UL upgrade from UL 498 to UL 60320-1.

Product Change Notification					2572 Change of marking		
owner	creation date	release date	released by	change order no	rev	page	D10-055-460
zeierjo	31.03.2021	31.03.2021	muehlema	2020484	B	1 of 2

Old product rating	New product rating
<p>Terminals in orientation A Front side</p>  <p>Back side</p> 	<p>Terminals in orientation A Front side</p> <p>„S „ removed</p>  <p>Back side</p>

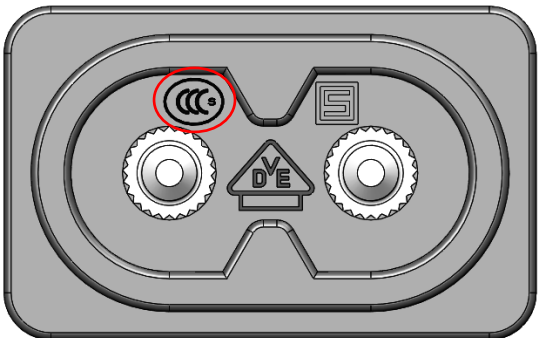
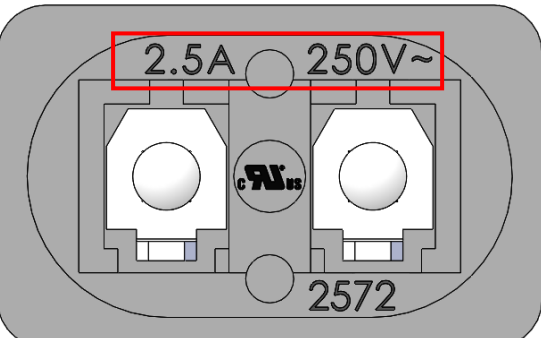
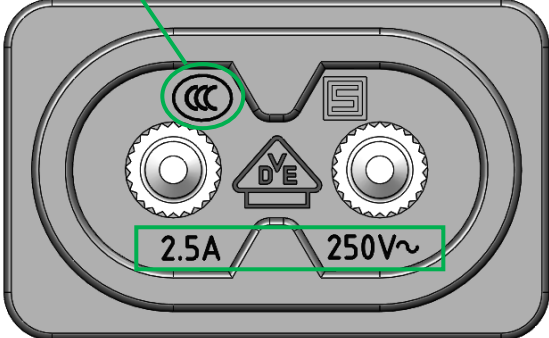
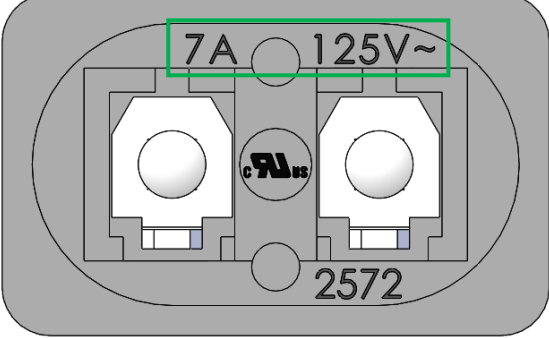
Marking for UL rating 7A/125V~ updated. Marking for IEC rating 2.5A/250V~ updated.

In the Chinese test mark CCC, the small S on the right of the third C has been removed.
